Hans Wittler Automotive, 121 Elizabeth St. NE, Traffic Circulation Layout, Architect's Stamp dated 3-5-14 (K21-D034)

Re: Wittler Auto Improvements, 121 Elizabeth St. NE

RE: Hans-Wittler Auto Addition, 121 Elizabeth St. NE Grading and Drainage Plan for Building Permit

WITTLER AUTO IMPROVEMENTS GRADING AND DRAINAGE PLAN

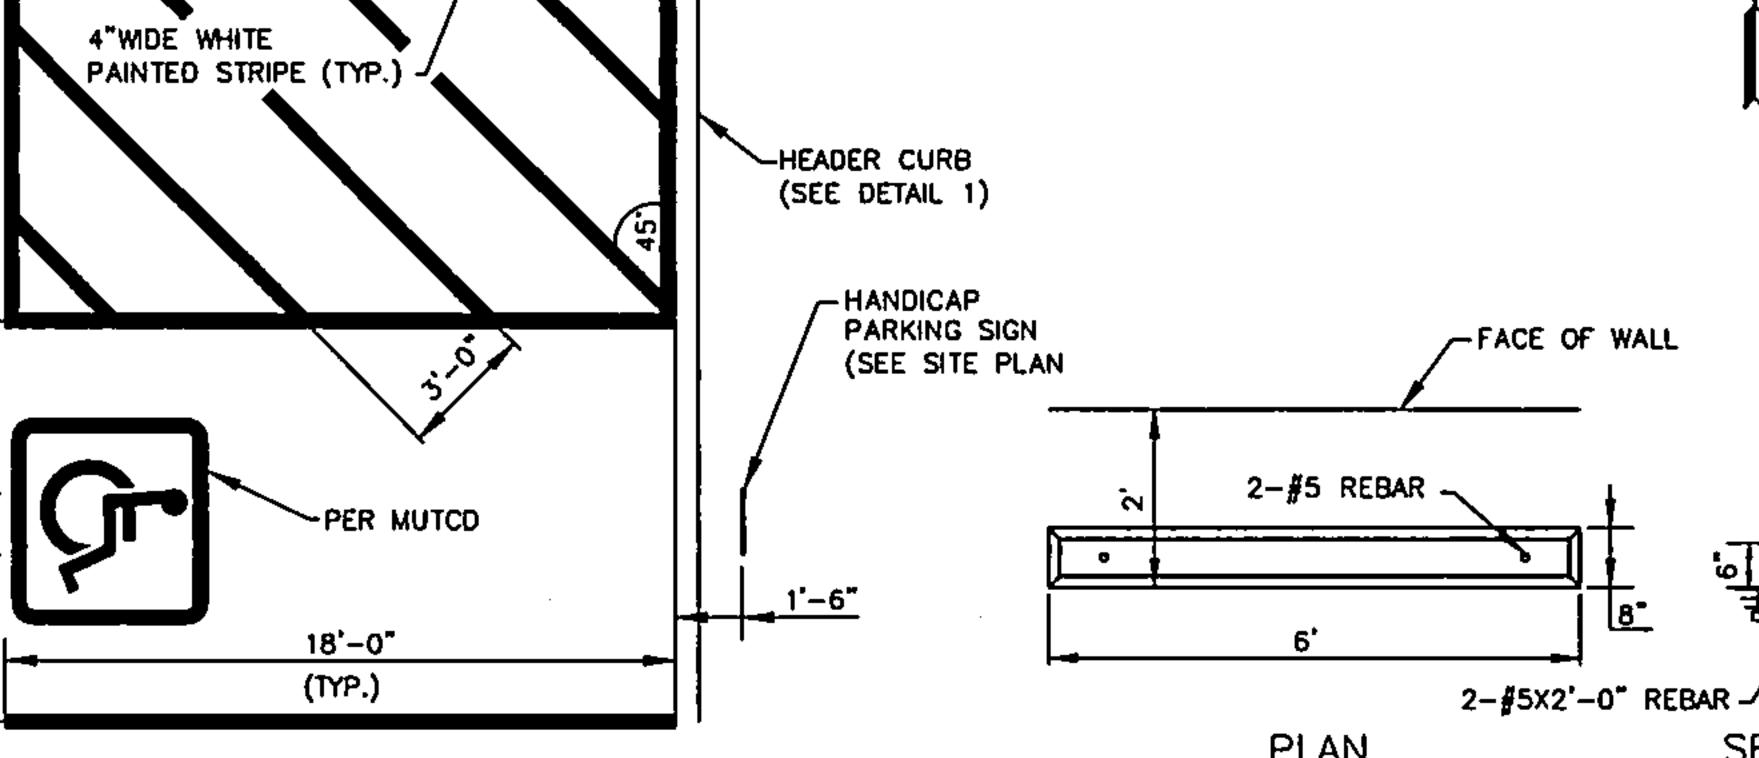
- 1. The volume of the pond in Area C does not seem to total the 1,032 cf that you indicate. I get closer to 635 cf. The southern portion is only 1' deep.
- 2. Is the southeastern, 8' wrought iron, perimeter fence intended to be in the 2' deep retention pond?
- 3. Is it possible to route more of the Area B flows through curb openings to the northern swale, before discharging from the site?
- 4. Shahab Biazar indicated to me that he previously requested that you provide documentation of the discharge rights or drainage easements at the historic outfall from the NW corner of the site. This documentation was not included in this submittal. Please provide verification.

A. Show how excess flows from the pond will overflow to the street. It looks like the existing grades near the N end of the pond may facilitate an overflow point that would allow the "Emergency Overflow" from the pond to drain down the reconstructed driveway entrance at the NE corner of the pond. To prevent street flows from backing up into the pond, it is necessary to keep that overflow grade top of curb, or at least 8" above street invert, unless you can demonstrate that street flows will be less than that depth. This may necessitate raising the top of pond elevation. The plus here will be resolution of the volume concern discussed above.

The volume shown on the plan is derived from the Average End Area method. I've revised the calcs utilizing the Conic Approximation method. Result is slightly less at 921cf. Please let me know if there is another method you'd prefer.

Two additional curb opening have been added.

DEPTH = 2.00 FT $V = (2.00 \text{ FT/3})[895 \text{ SF} + 137 \text{ SF} + (895^{1}37)^{0.5}] = 921CF$

SHEET TITLE SITE PLAN

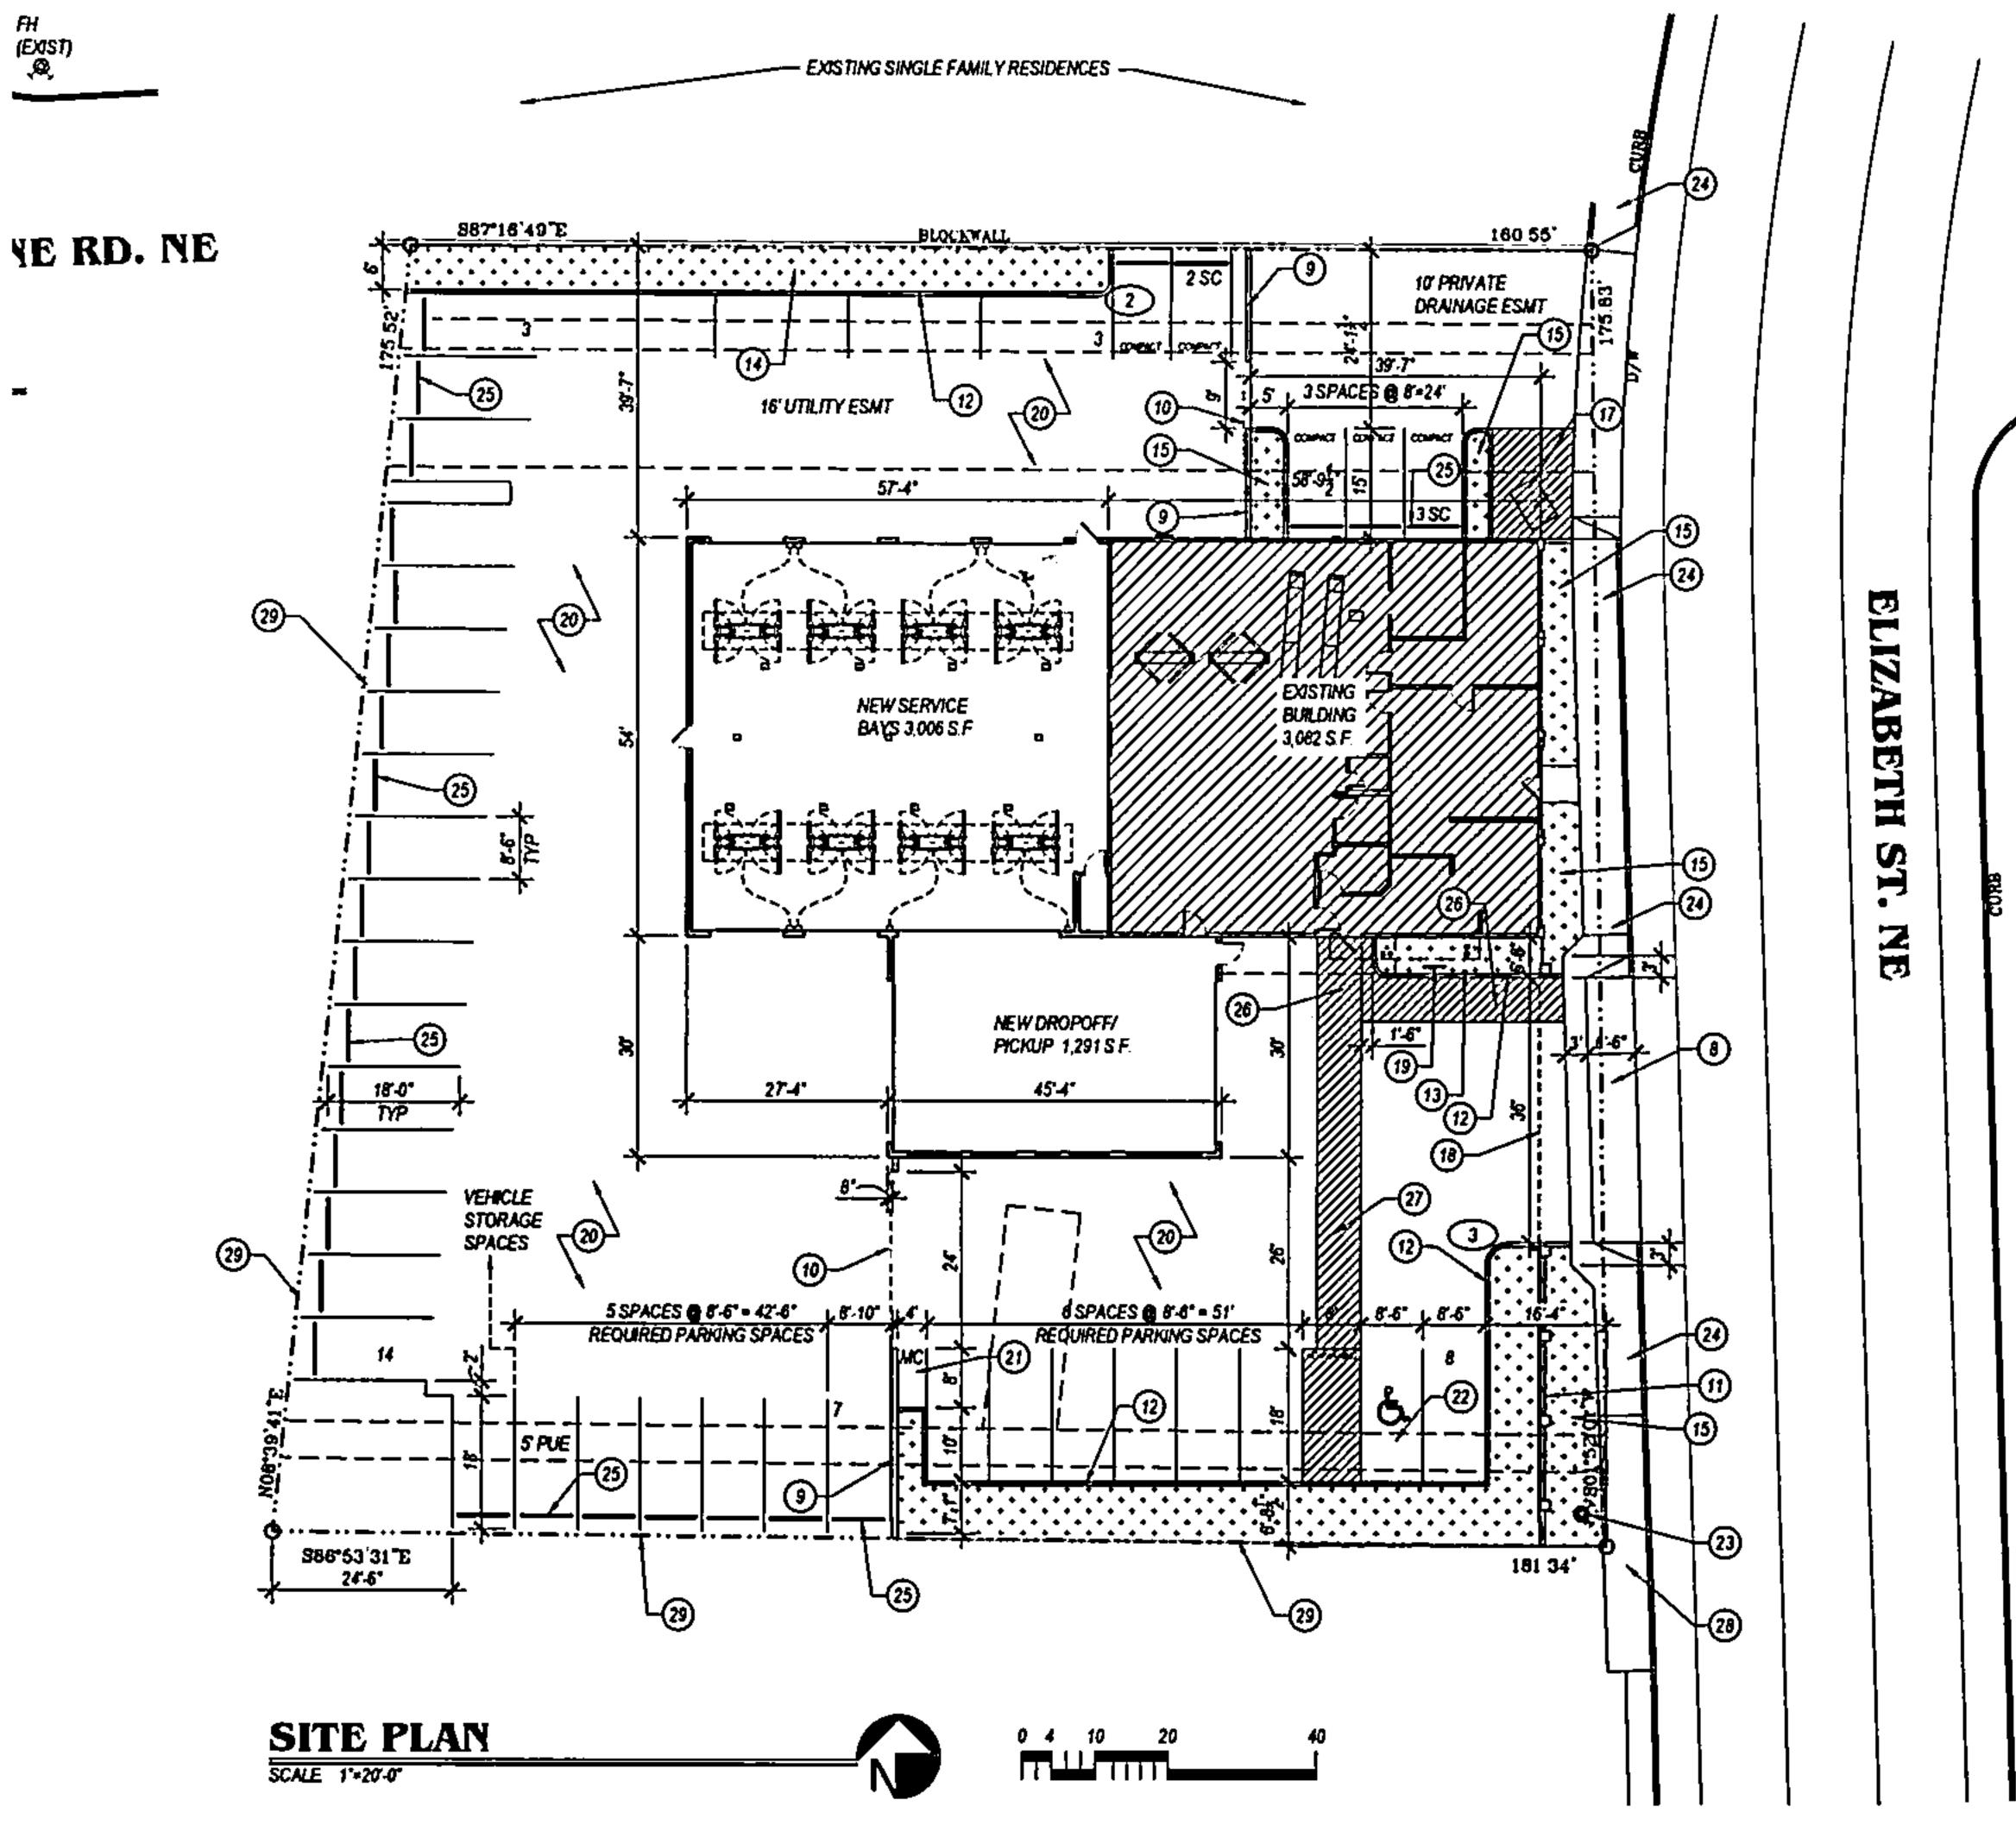
Per our phone conversation, 2/14/14, please remove the pavement striping (Key note 26) from the TCL presented in your latest attachment. As discussed, the striping is within the vehicle driveway, running parallel to the vehicle path and is not a safe choice for a designated pedestrian path. Zoning requires an ADA accessible path from the COA ROW to the building but does not require the path to be delineated. As long as the approved TCL meets Zonings requirement for pedestrian accessibility, the DPM request for a designated path is waived for this site.

Please reference attachment regarding recently revised ADA Parking requirements. The HC posted sign must say "violators will be towed" and the striping on the handicap access aisle must be blue with "No Parking" at the end of aisle.

Based upon the information provided in your submittal received 2-20-14, the above referenced plan cannot be approved for Building Permit until the following comments are addressed:

- 1. The development of this site must be in compliance with current DPM and ADA standards and regulations
- 2. The demolition plan indicates a shared driveway on the adjacent lot to the south to be removed and replaced with new sidewalk, standard curb & gutter.

- 3. The demolition plan indicates existing driveway to the north to remain. Please provide existing details and dimensions.
 - Drivepad does not appear to be compliant with current DPM and ADA standards.

- Drivepad appears to be asphalt with an inverted crown, and no ADA pedestrian sidewalk.
 - Drivepad is proposed to be the access for Refuse, and therefore drivepad/sidewalk must be reinforced concrete, 6inch thick. Please provide details or reference COA Std. Dwg #2428 for Alley Intersection.

Please see the attached revised plan. I removed the clouding but I did make the following changes:

- 1. Revised the accessible parking details to address the accessible parking requirements.
- 2. Added a note under the parking calculations to paint "compact" at each space and have shown it on the plan.
- 3. Added the dimension for the gate.

Regarding the access from the ROW, I can't put a curb there because it will conflict with the entry into the drop off bay. At this point, I don't know how we can change it. I understand your concern, but realistically, patrons will be using the parking lot to drop off or pickup their cars. I don't think there will be very many "walk-ins".

Thanks for discussing the site plan changes with me earlier today. Please see the attached revised plan. I reworked the NE area of the site. I left the existing driveway the entire width so the Refuse truck can still access the container. I think it will work since I added some protection for the parking spaces. I did lose a couple, but still have enough to meet the parking demand and the car storage amount the Owner wanted.

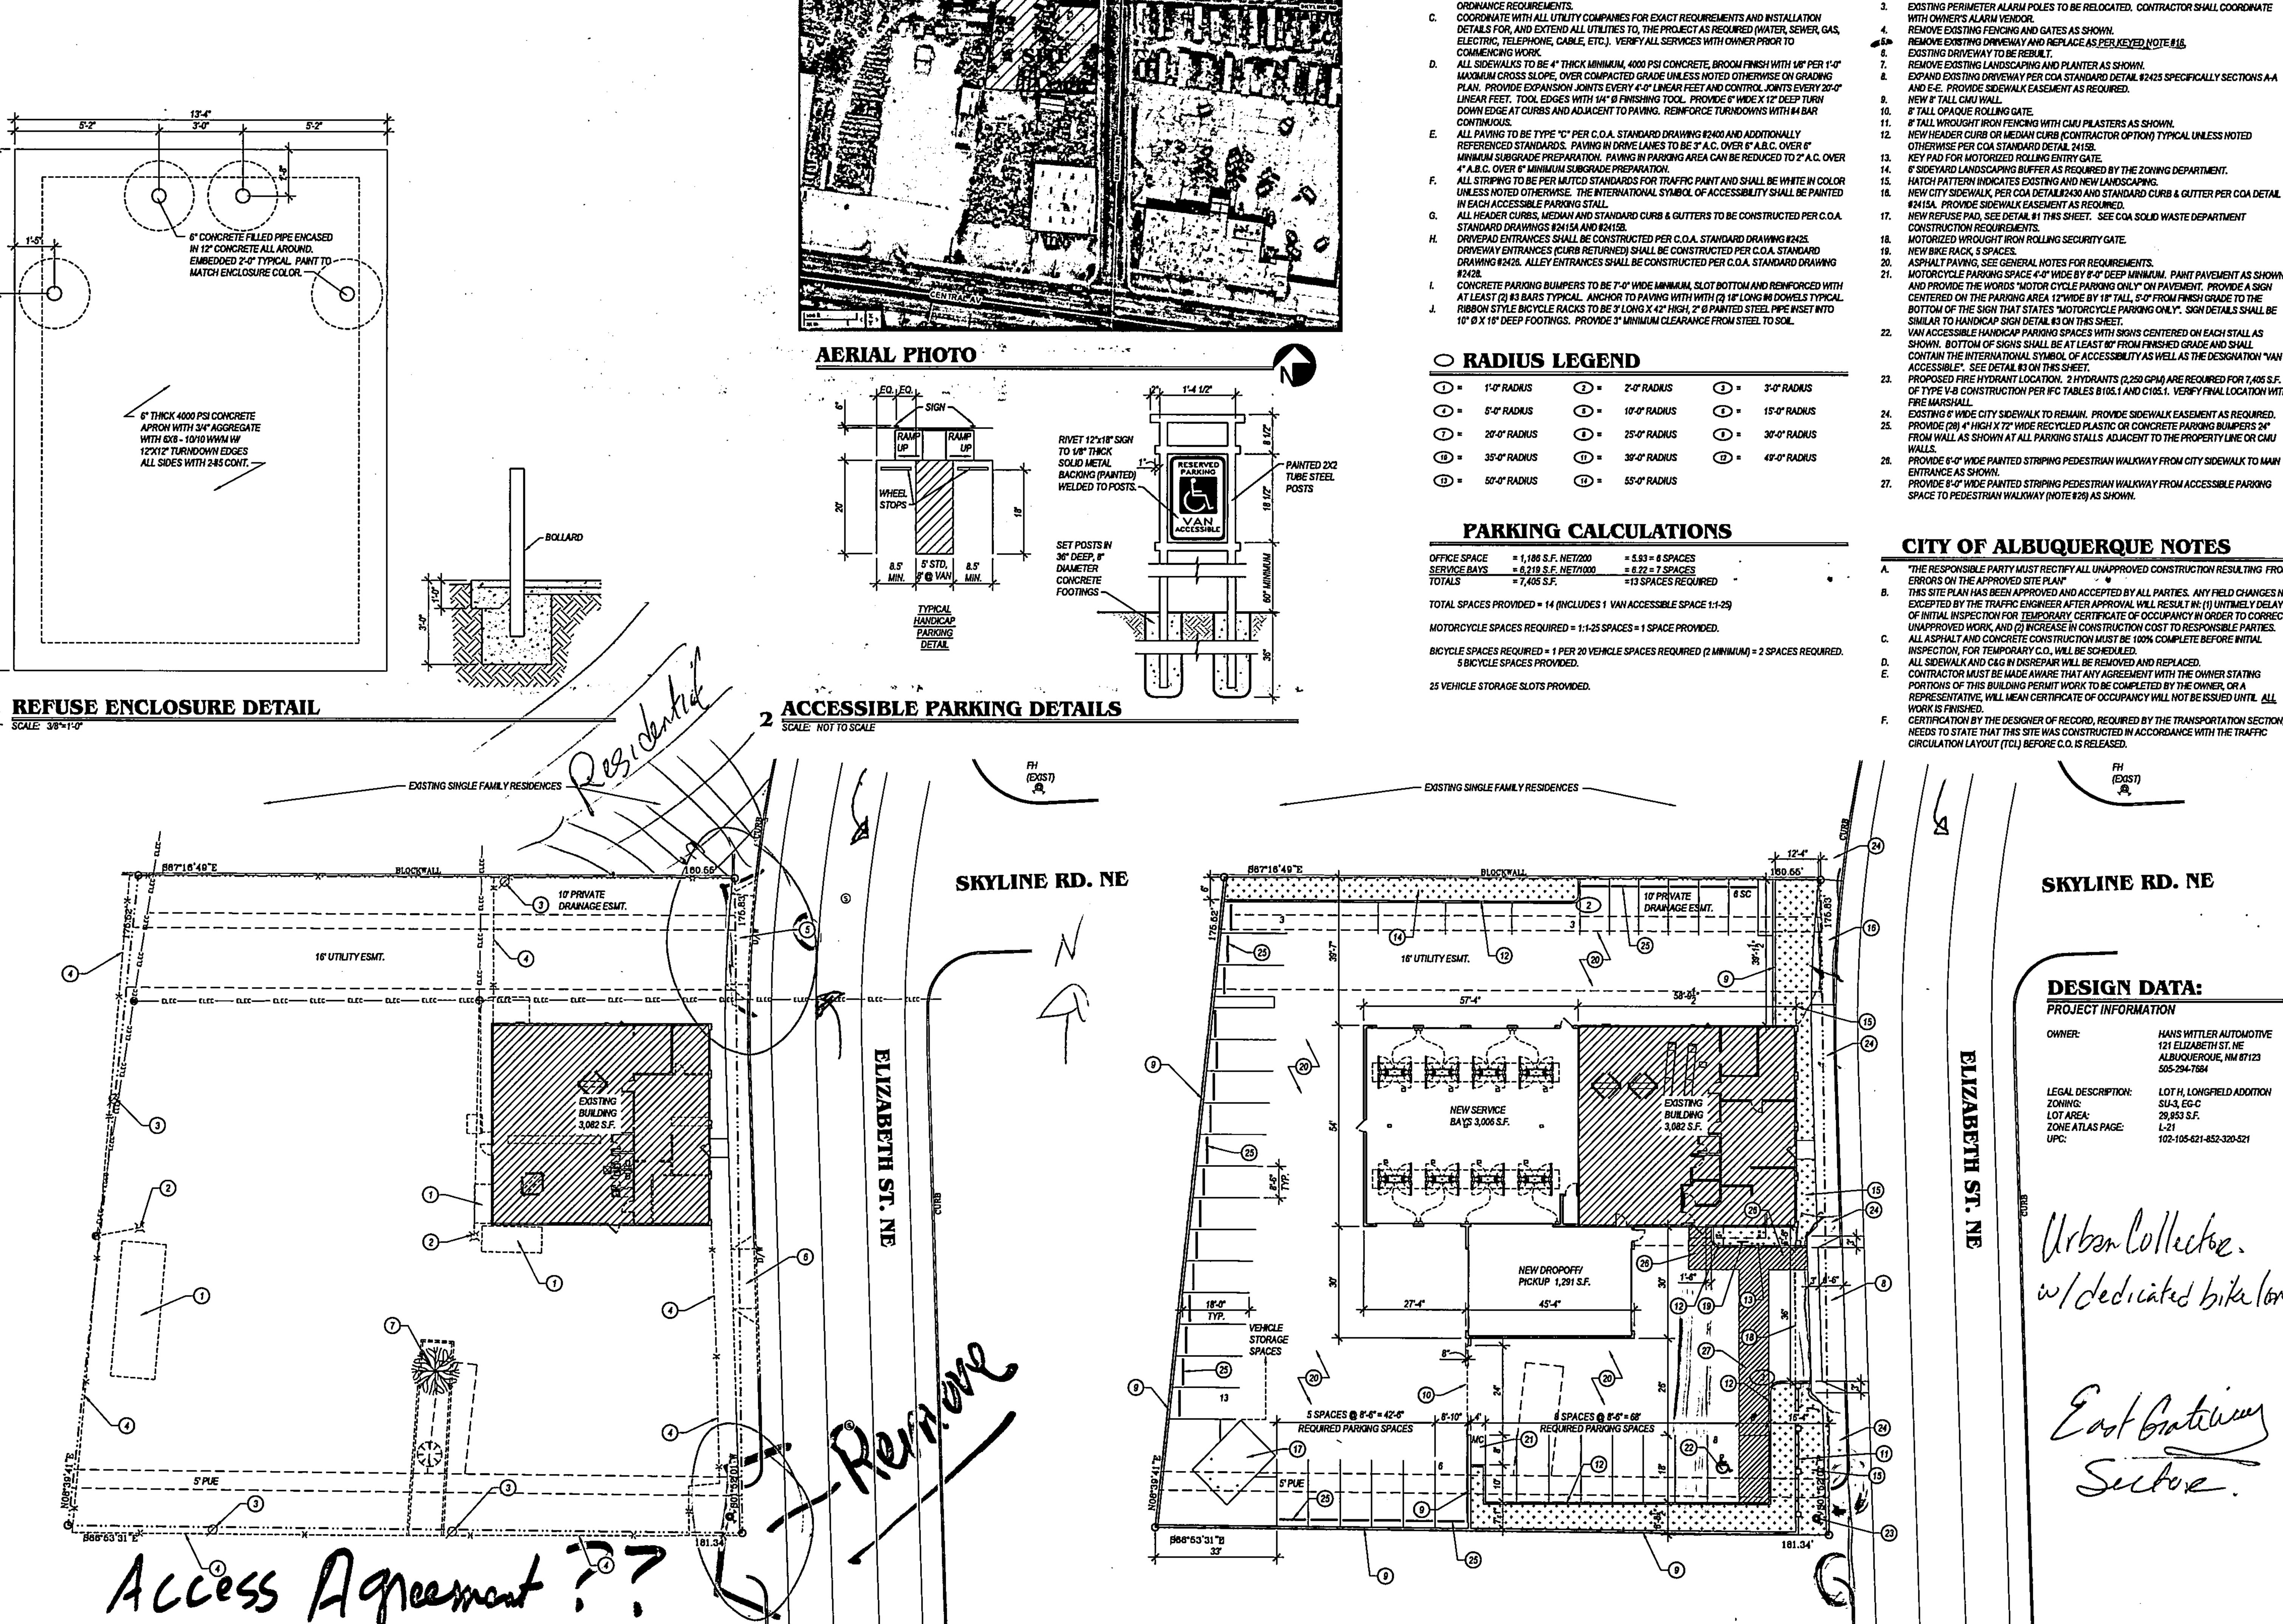
- 1. Define width of the existing sidewalk. Note #24 added, 6' wide
- 2. Keyed note #16, new city sidewalk, needs to include new curb and gutter per COA detail #2415A. Modified note to include standard C&G.

- 3. Does the COA sidewalk encroach onto private property? If so, a Sidewalk Easement will need to be obtained. Yes. Easement note added to #24.
- 4. Show a detail of the wheelchair ramps located at the proposed driveway, or refer to the appropriate city standard. Note #8 refers to 2425.

- 5. The site plan indicates an existing curb cut between site and adjacent property to the north. This curb cut must be removed and replaced with sidewalk, curb and gutter per COA standards. Existing note #5 modified to reference #16.

- 6. Parking areas shall have barriers which prevent vehicle encroachment and which shall be located two feet from any abutting lot, wall or fence. New note #25 added.

- 7. Pedestrian walkway shall be provided from street sidewalk to the principal customer entrance. It shall be a minimum of six feet in width, unobstructed, clearly demarcated, and ADA accessible. New note #26 added.

- 8. Pedestrian walkways shall be provided from handicap parking access aisle to the principal customer entrance. It shall be a minimum of six feet in width, unobstructed and clearly demarcated, and ADA accessible. New note #27 added.
